Subject: P.H.O. APPLICATION NO. PHO-1-24--Z-SP-11-05-7 – Notice of Pending Actions by the **Planning Hearing Officer**

APPLICATION NO: PHO-1-24--Z-SP-11-05-7

Request For: Stipulation Modification

Request for Modification and Deletion of Stipulations: Z-SP-11-5

PRELIMINARY SITE PLAN
GMS CONCRETE SPECIALISTS

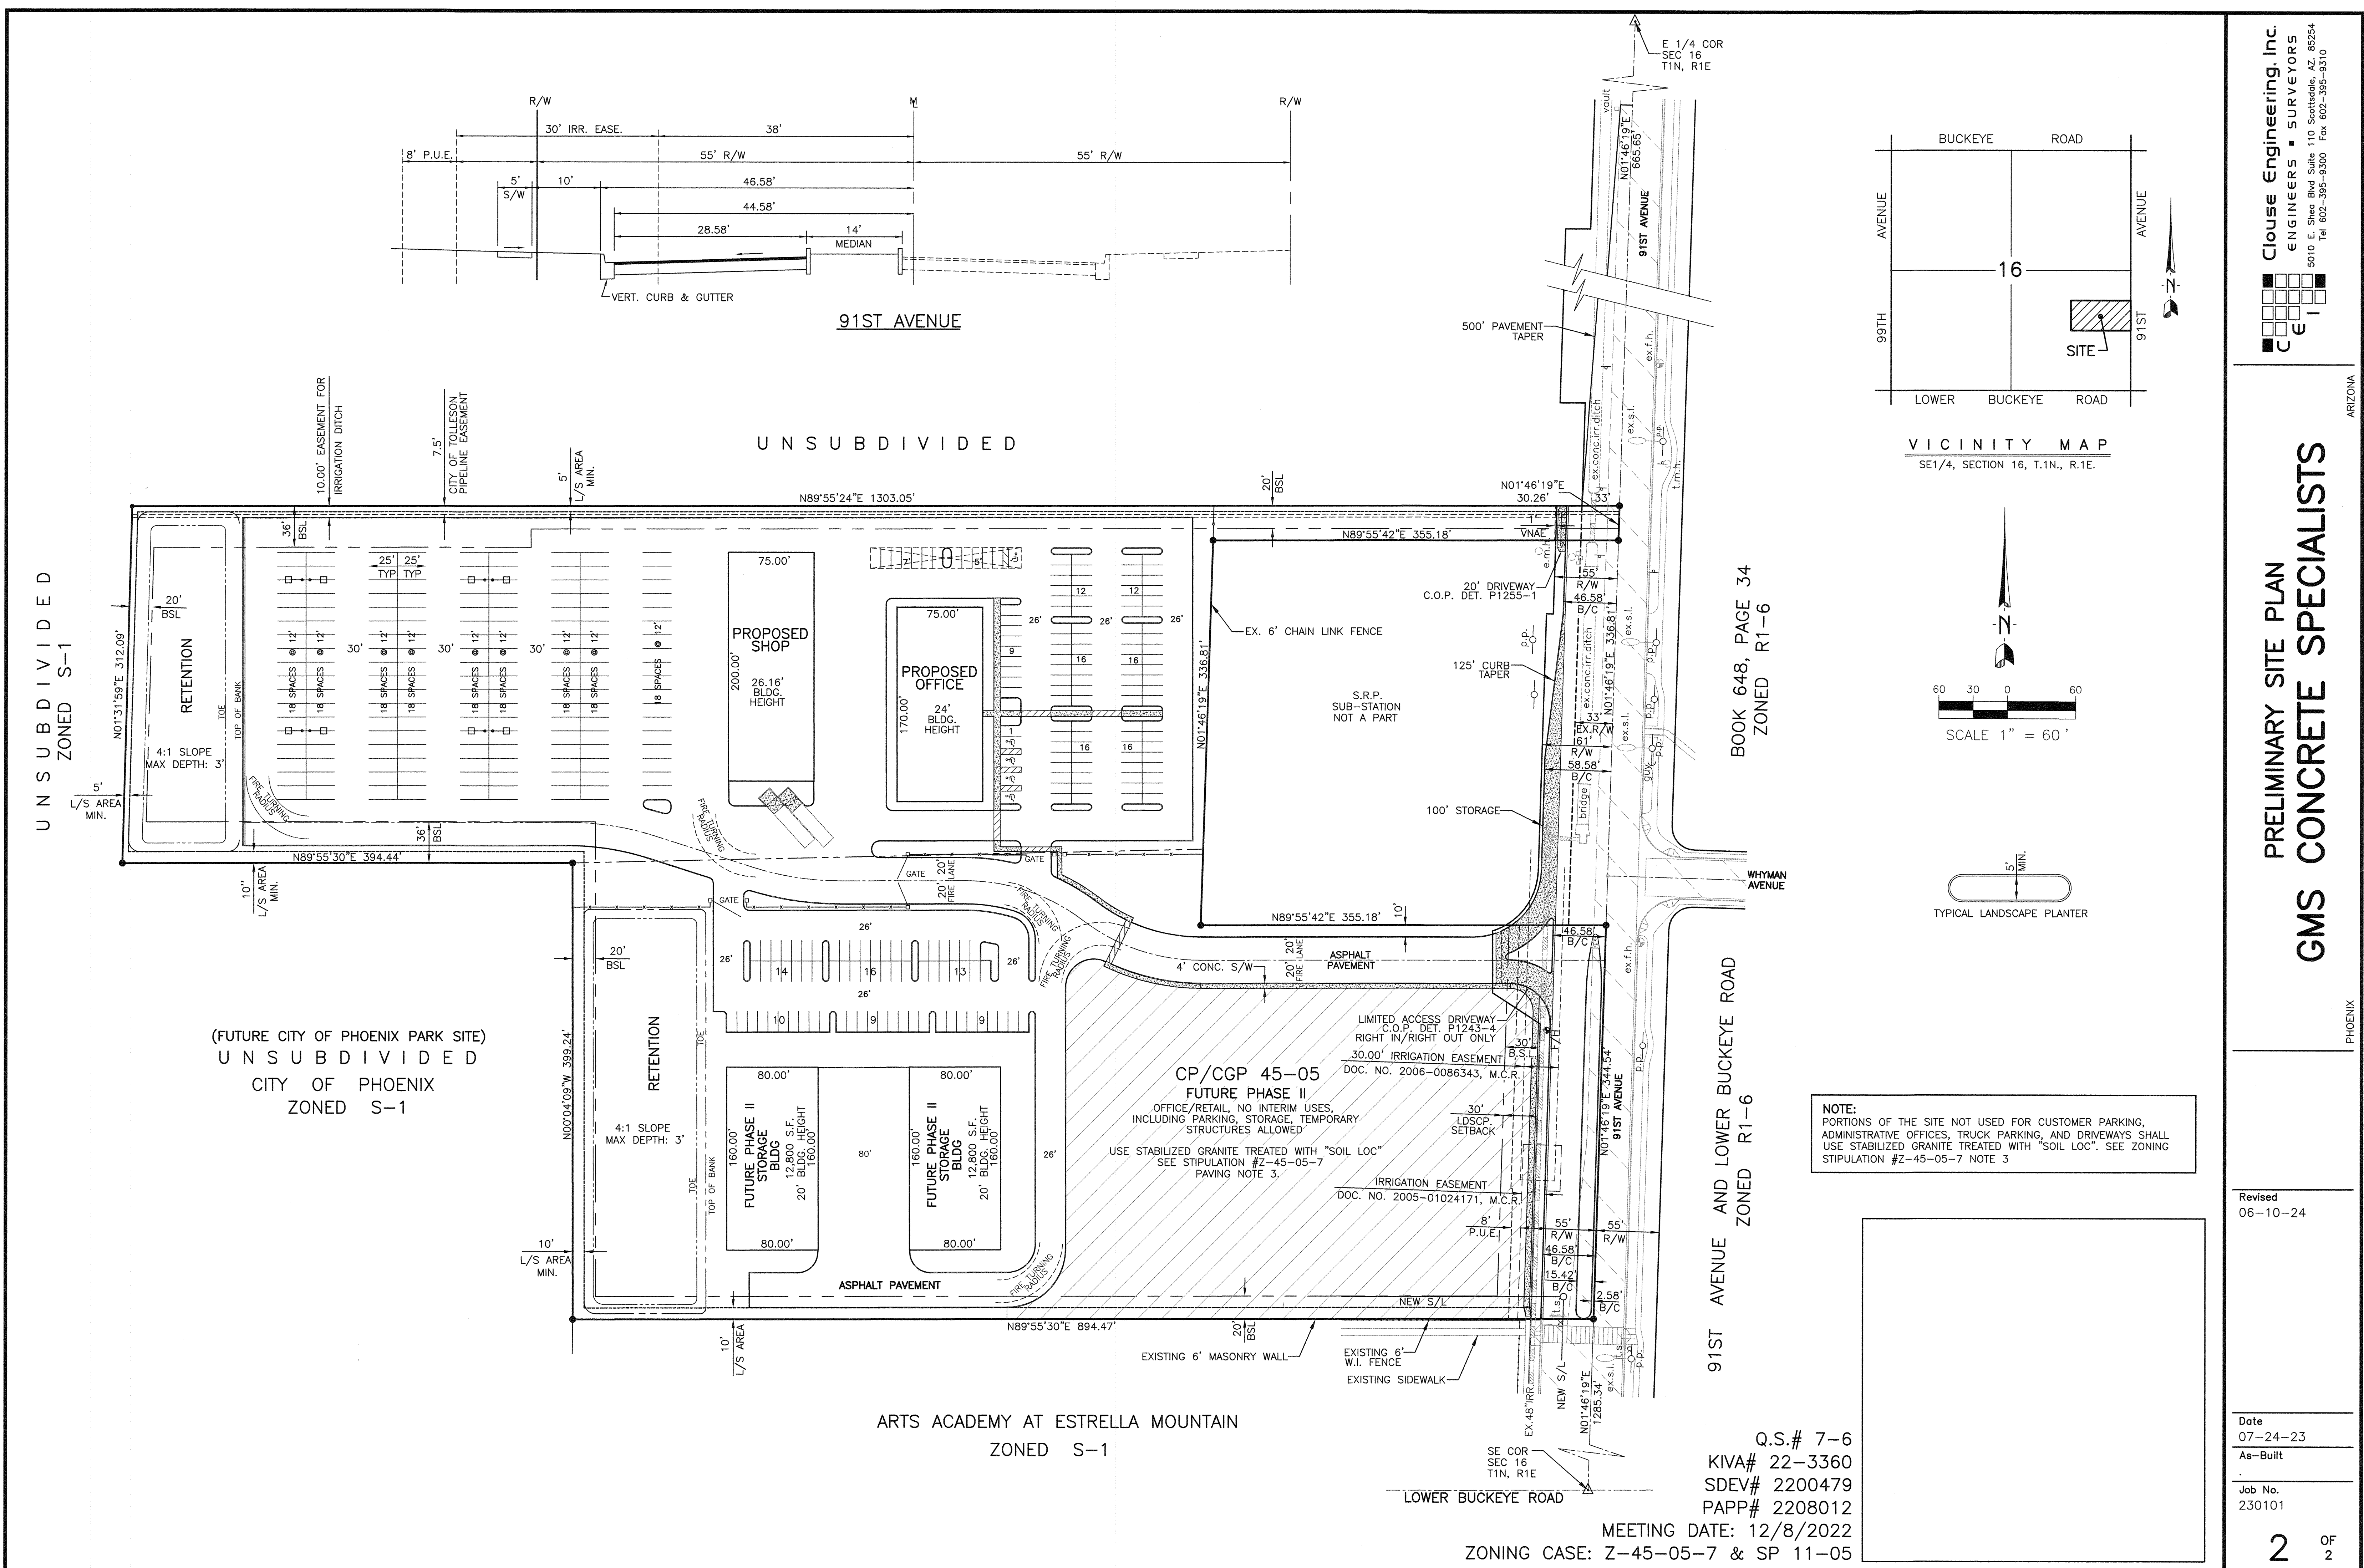
Since the 2005 stamped site plan, GMS has updated the site plan to relocate the office building and storage buildings from the CP/GCP area to the CP/GCP -SP area, relocated and added parking spaces, and has reduced the number of driveways into the site from two to one primary driveway and one fire access driveway. Furthermore, GMS plans to develop the southern portion of the project in a future phase which differs from the August 2005 site plan. While these changes differ from the site plan date stamped August 1, 2005, the overall proposed development fulfills a similar intent to what was originally proposed.

The site plan dated August 2005 identified a dust-proofed area in the southwest area of the site. This area has since been identified as an area appropriate for a retention area, future storage buildings, and asphalt pavement for parking.

Due to the proposed development of the dust-proofed area on the August 2005 site, per Stipulation #1C of Z-SP-11-05, the site plan must be reviewed and approved by the Planning Hearing Officer. Additionally, the proposed site plan included with this application no longer identifies a dust-proofed area, therefore, this stipulation will no longer be applicable if the proposed development on the dust-proofed area is approved through this PHO process.

Stipulation No. 1. That the site shall be developed in general conformance to the site plan date stamped ~~August 1, 2005~~ **JULY 3, 2024** as modified by the following stipulations and as approved or modified by the Development Services Department.
